# Florida Keys Aqueduct Authority

RE: Florida Power and Light Company  
Turkey Point Power Plant – Wastewater Permit No. FL0001562  
Response to FPL Letter to ORCA, dated September 26, 2019

MAP SHOWING FKA Wellfield, Monitor Wells, and Salinity Contours

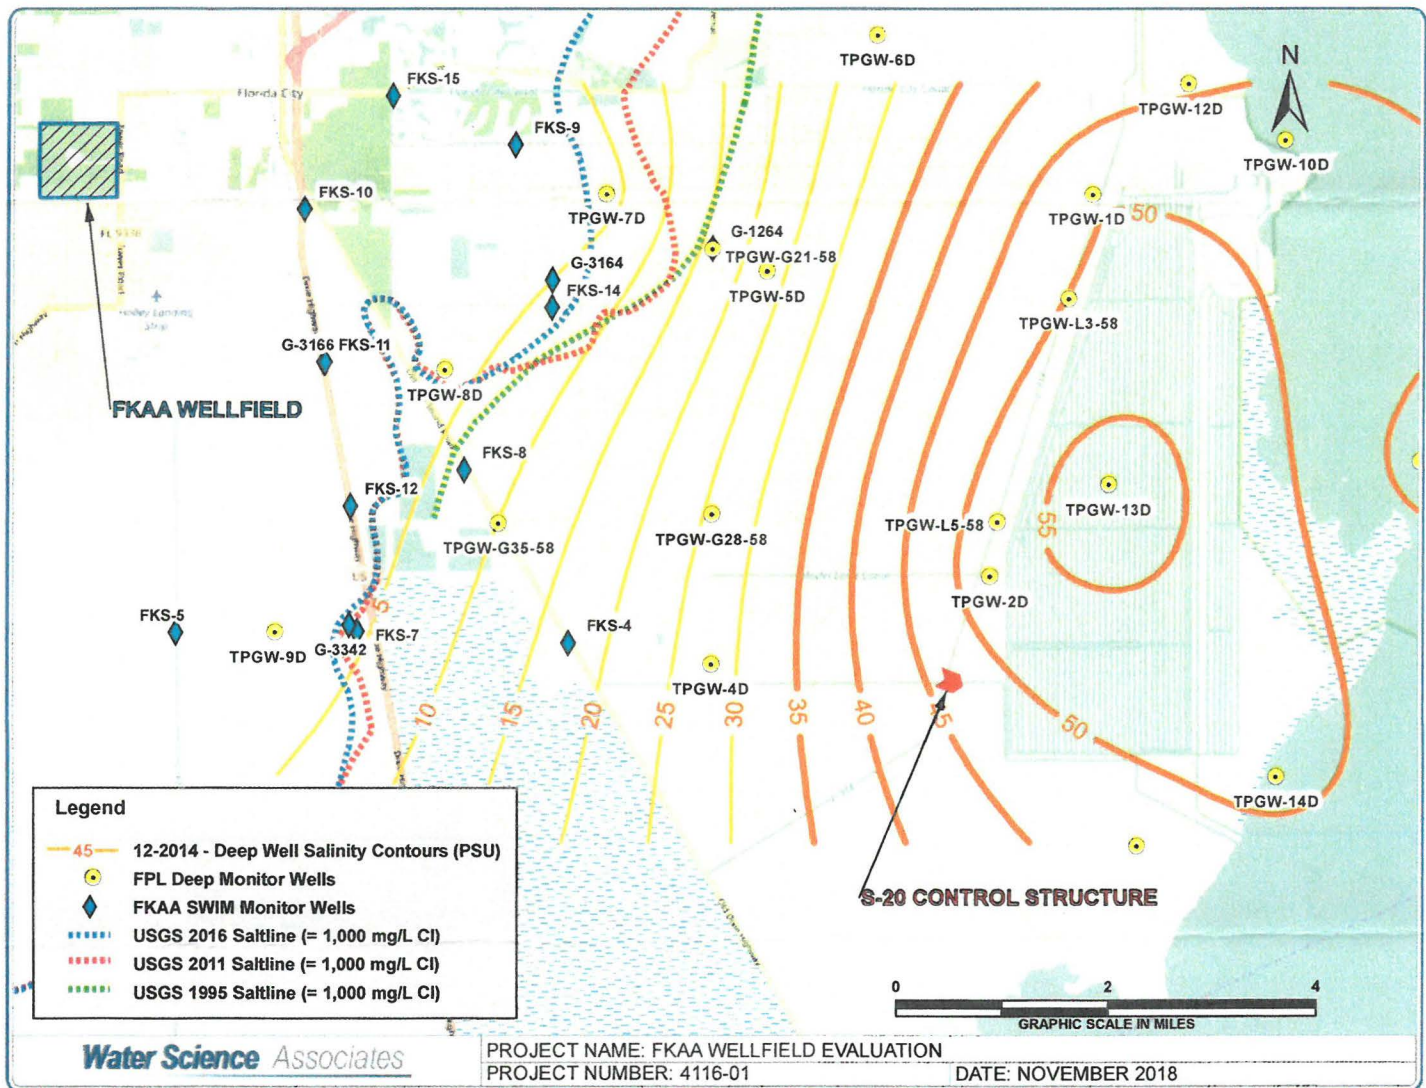
With regard to distances of various salinity tritium contours from the FKAA municipal water supply wellfield, we have attached two diagrams showing recent salinity and tritium data collected from monitoring stations owned and operated by FKAA, DERM, the USGS, and FPL showing that the hypersaline plume extends approximately 2 miles from the CCS (7-8 miles from FKAA wellfield); the saltwater water interface extends 5-6 miles from the CCS (3-4 miles from FKAA wells); and the elevated tritium plume extends 4-5 miles from the CCS (4-5 miles from FKAA wells). These diagrams show a clear relationship between the hypersaline plume, the saline water interface, and the tritium plume originating at the FPL Turkey Point facility
